**BEFORE
THE OHIO POWER SITING BOARD**

In the Matter of the Application of)	
Kingwood Solar I LLC for a Certificate)	Case No. 21-0117-EL-BGN
of Environmental Compatibility and)	
Public Need)

**KINGWOOD SOLAR'S JUNE 1, 2021 RESPONSES
TO STAFF'S MAY 17 AND MAY 20 DATA REQUESTS**

Figure DR3-5-1
Non-Participating Adjacent Residential Structures with Unobstructed Direct Line-of-Sight

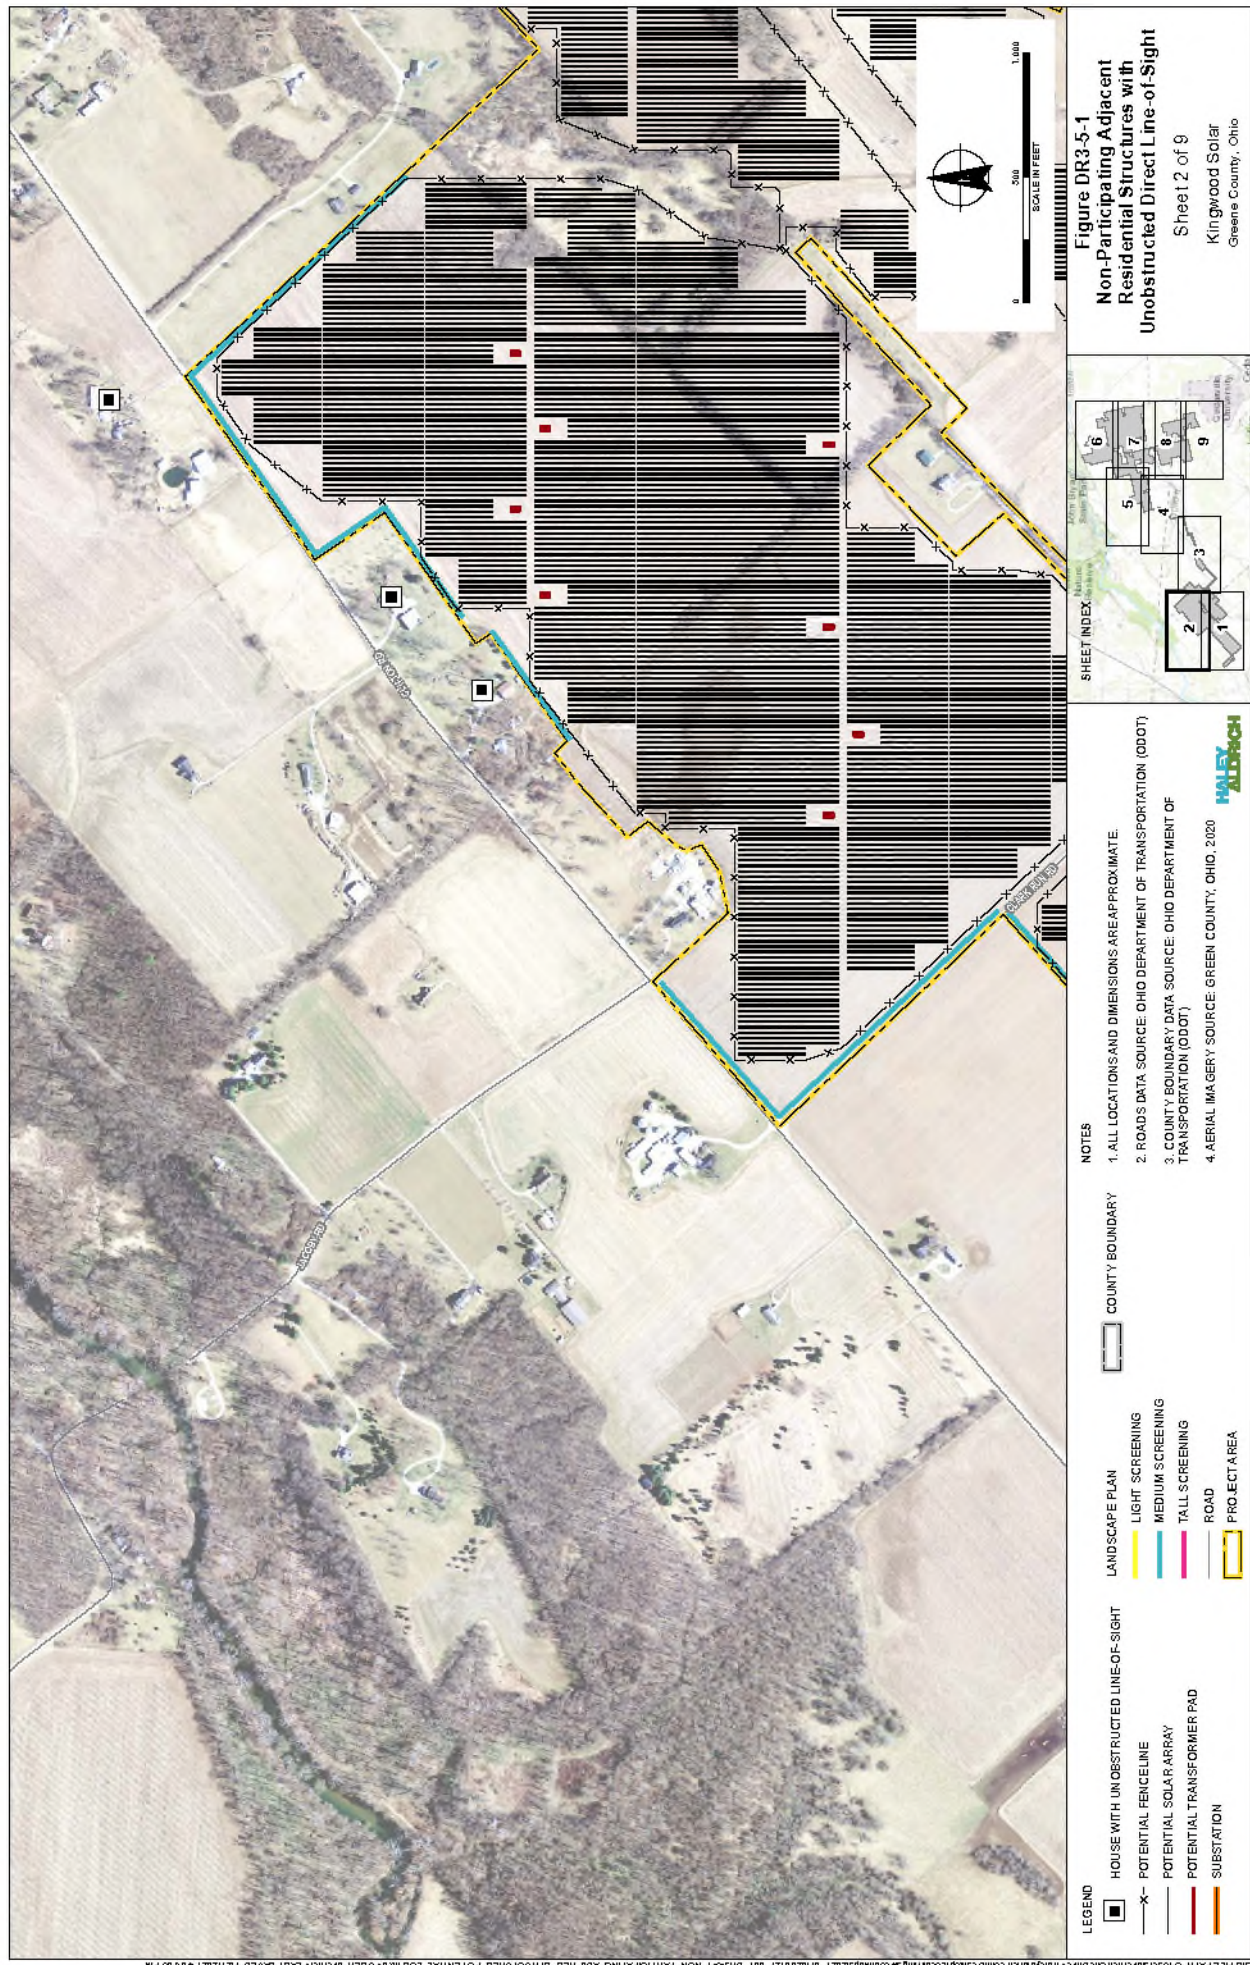
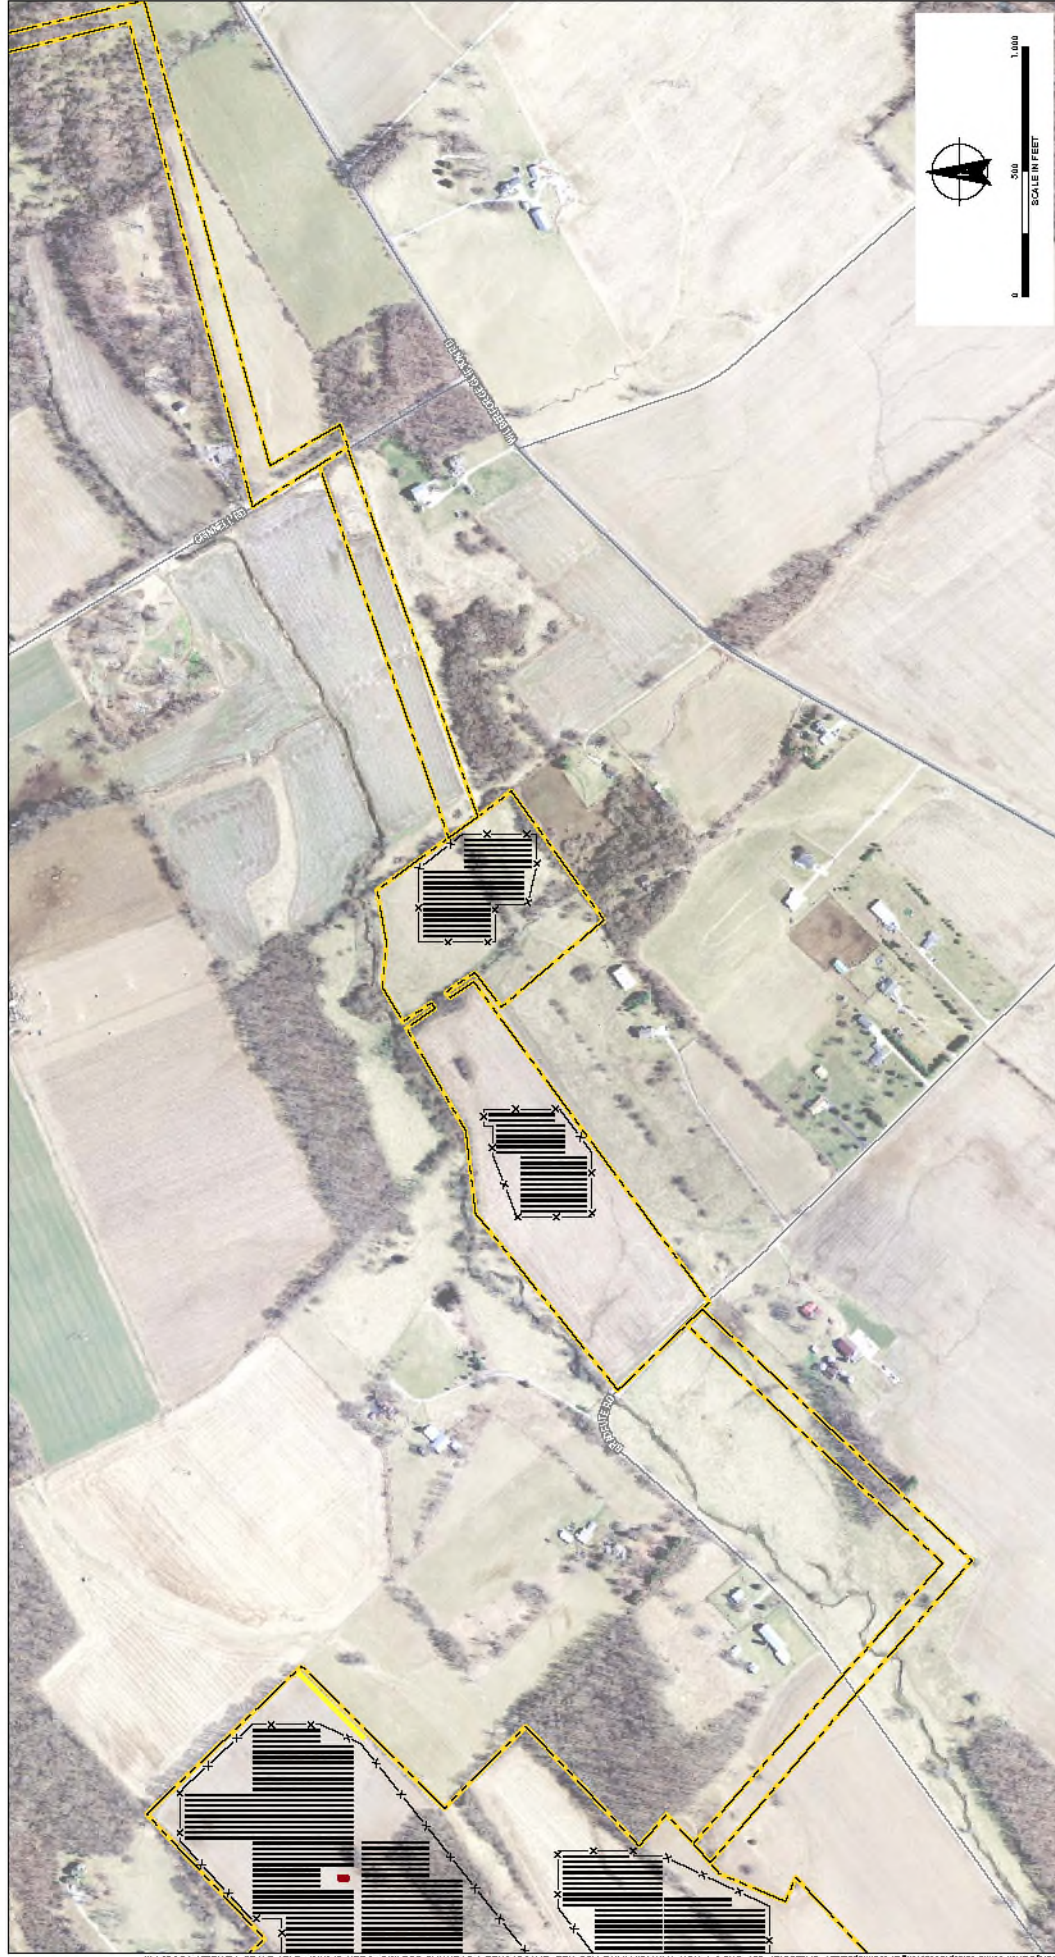
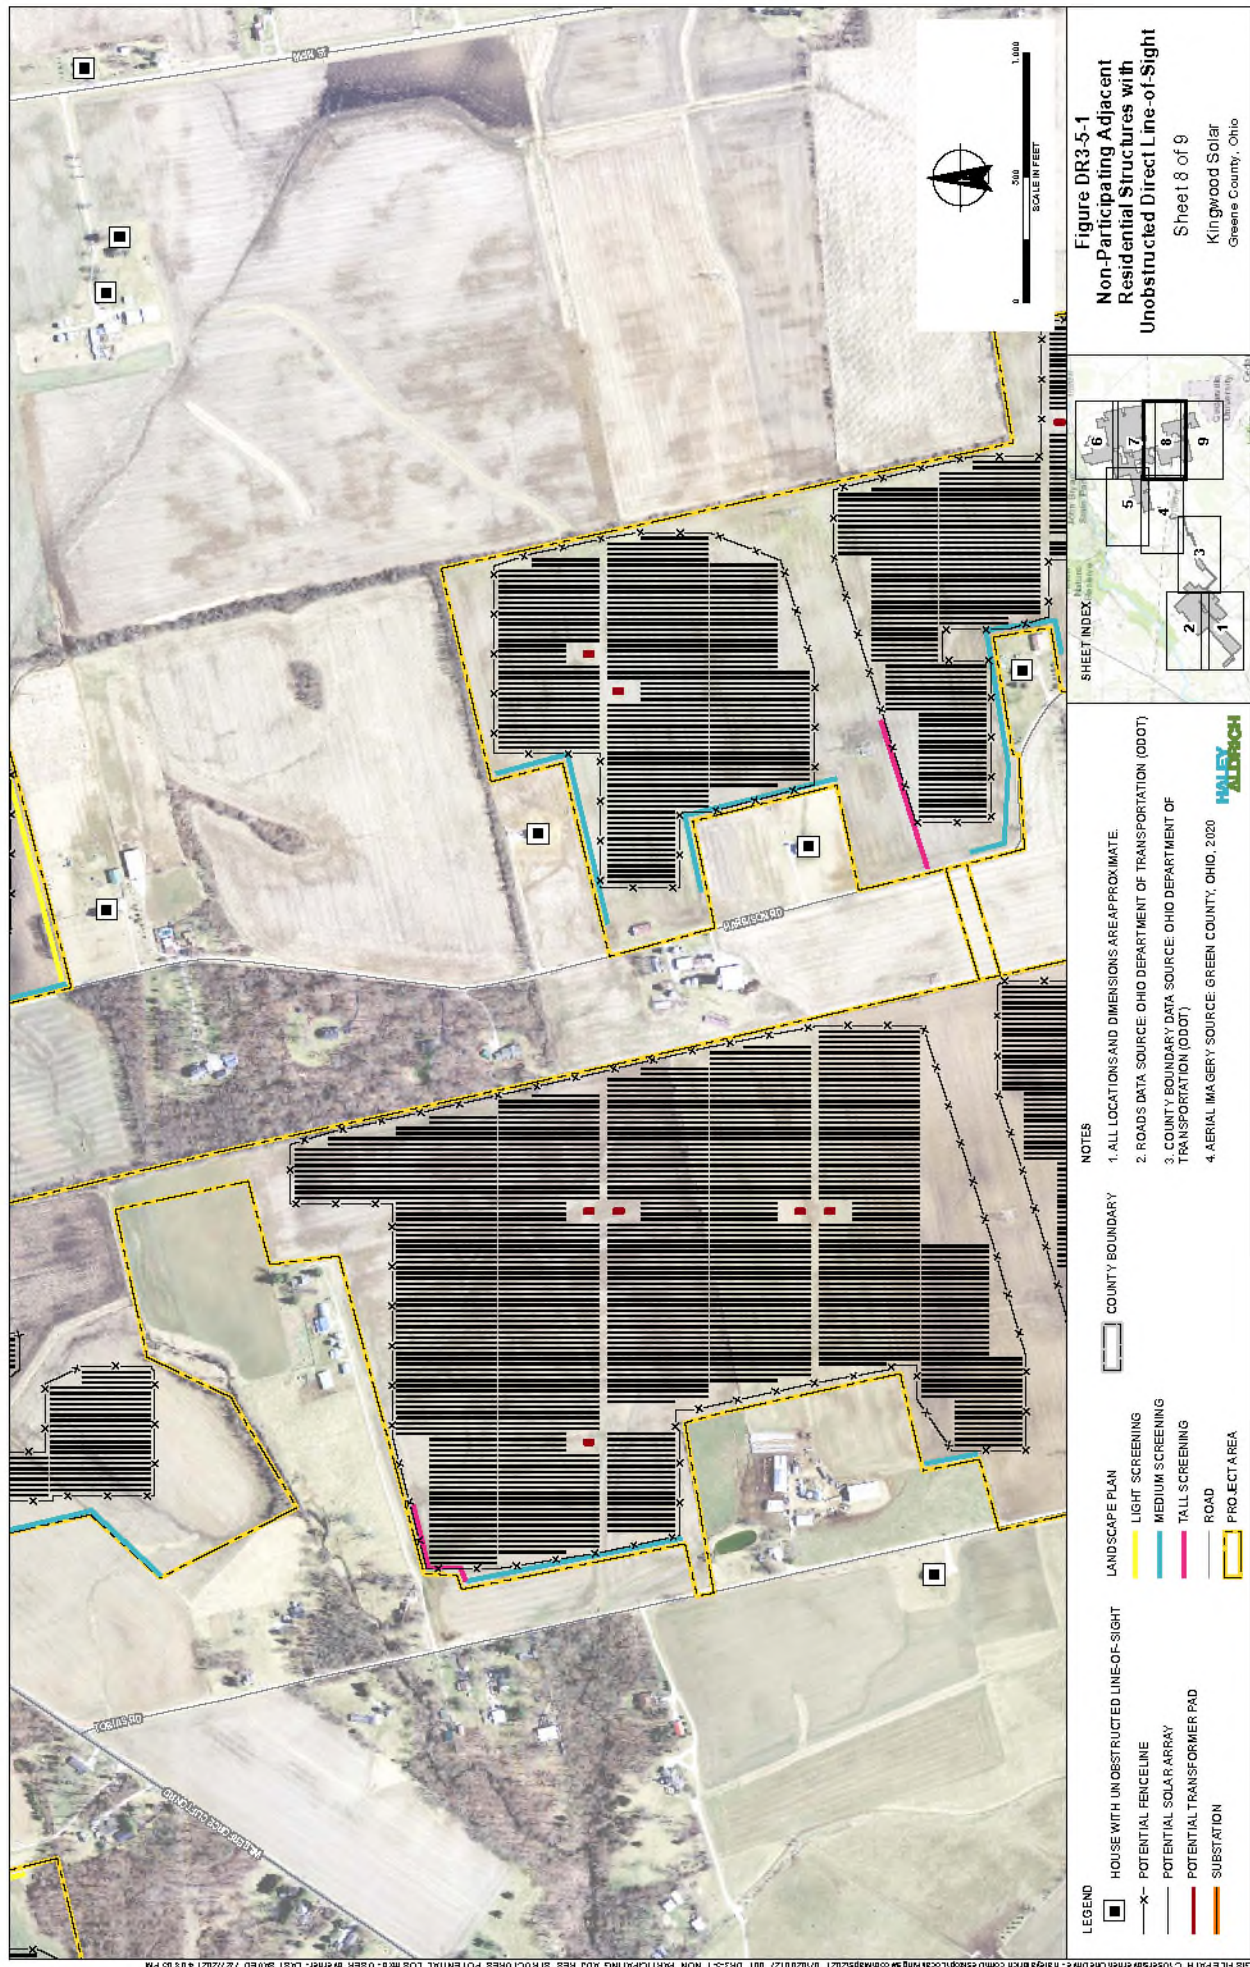
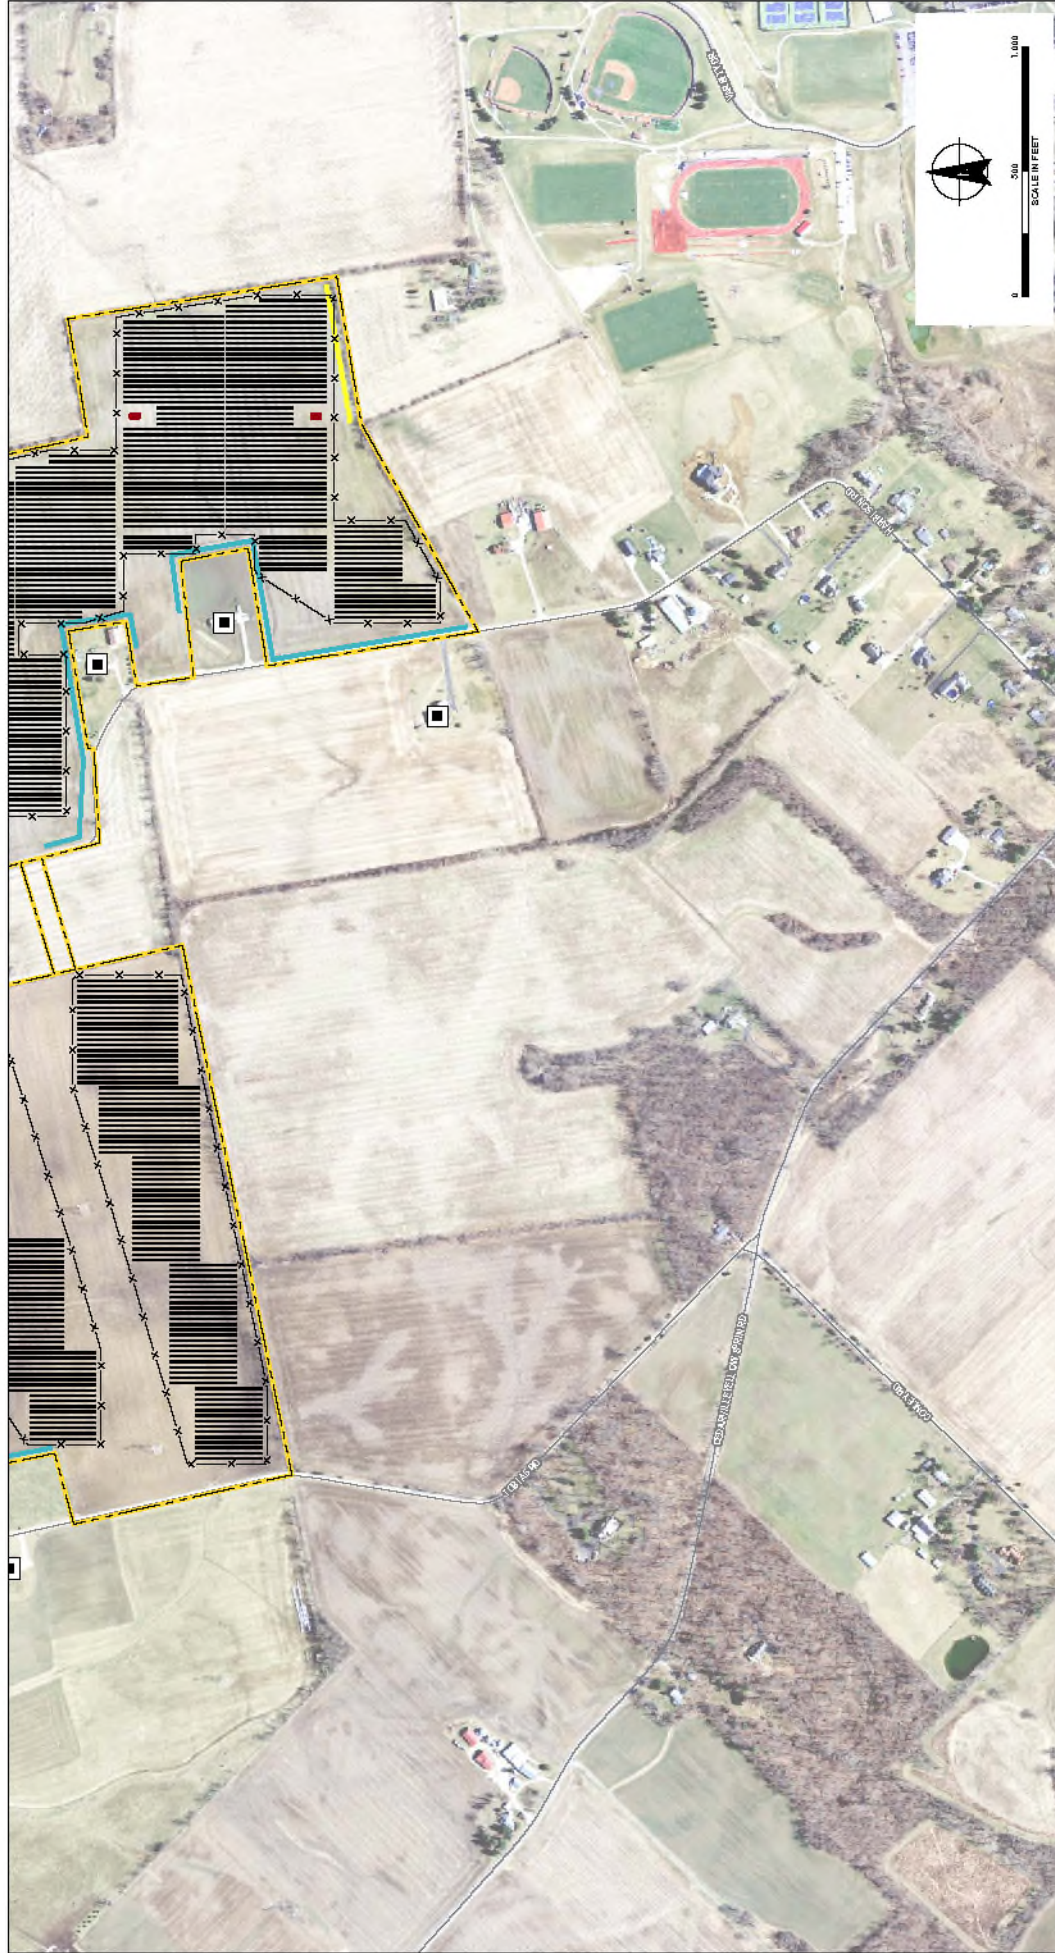
See attached Figure DR3-5-1 for non-participating residential dwellings adjacent to the Project Area that have an unobstructed line-of-sight to the Project Area boundary.
